UNITED STATES PATENT AND TRADEMARK OFFICE

APPLICATION NO.	FILING DATE	FIRST NAMED INVENTOR	ATTORNEY DOCKET NO.	CONFIRMATION NO.
10/013,981	12/10/2001	Chia-Hui Han	JCLA7632	1935

Office Action Summary

DETAILED ACTION

FIG. 1 (PRIOR ART)

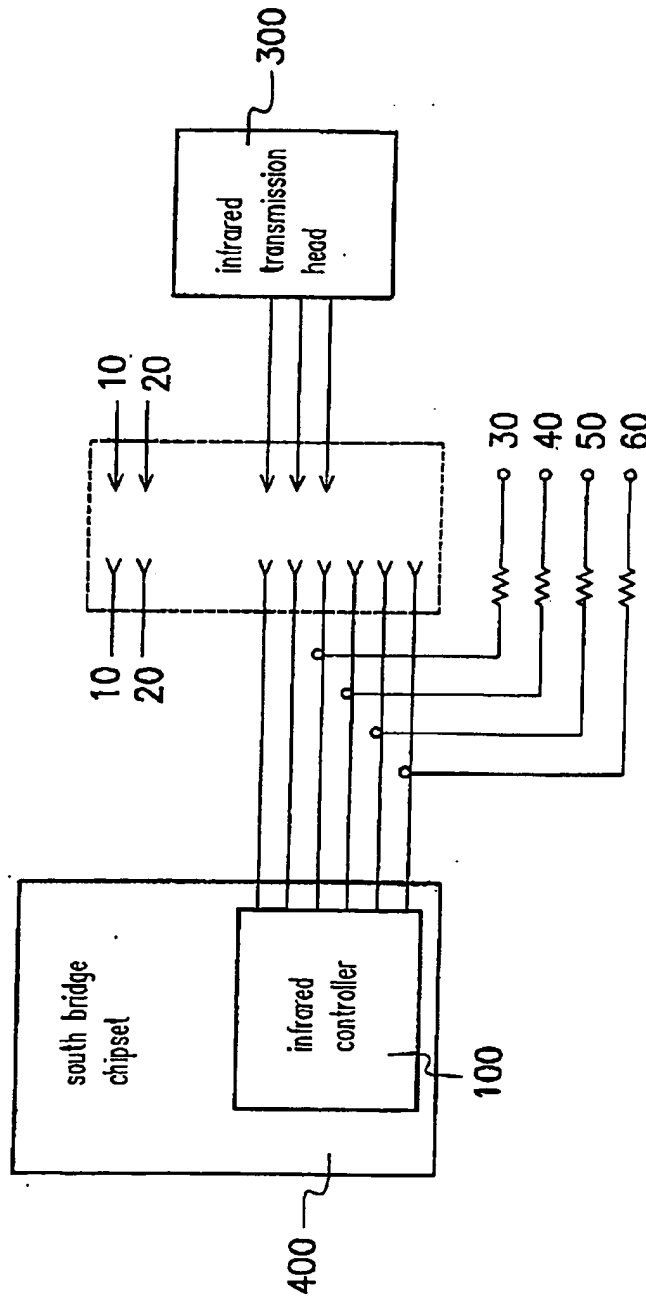
4. Claims 5 and 14 are rejected under 35 U.S.C. 103(a) as being unpatentable over Verzulli in view of Kamon et al. or Chiloyan et al. as applied to claims 1-3 and 6-12 above, and further in view of admission (admitted prior art FIG. 1 and FIG. 2).

Verzulli, Kamon et al. and Chiloyan et al. have been discussed above in regard to claims 1-3 and 6-12. The difference between Verzulli, Kamon et al. and Chiloyan et al. and the claimed invention is that Verzulli, Kamon et al. and Chiloyan et al. do not disclose that the infrared controller is enclosed within a South Bridge control chipset. However, FIG. 1 (prior art) of instant application teaches that infrared controller 100 is enclosed within a South Bridge chipset 400. South Bridge chipset is commonly used for connecting peripheral devices to the North Bridge chipset in a computer motherboard. One of ordinary skill in the art would have been motivated to combine the teaching of admission with the modified self-test arrangement of Verzulli, Kamon et al. and Chiloyan et al. to include the infrared controller within a South Bridge chipset for applications where the IR transceiver is a peripheral device because such arrangement has become a de facto industrial standard. Thus it would have been obvious to one of ordinary skill in the art at the time the invention was made to include the infrared controller as part of a North Bridge chipset for applications where the IR transceiver is a peripheral device of a computer, as taught by admission, in the modified self-test arrangement of Verzulli, Kamon et al. and Chiloyan et al. because such arrangement has become a de facto industrial standard.
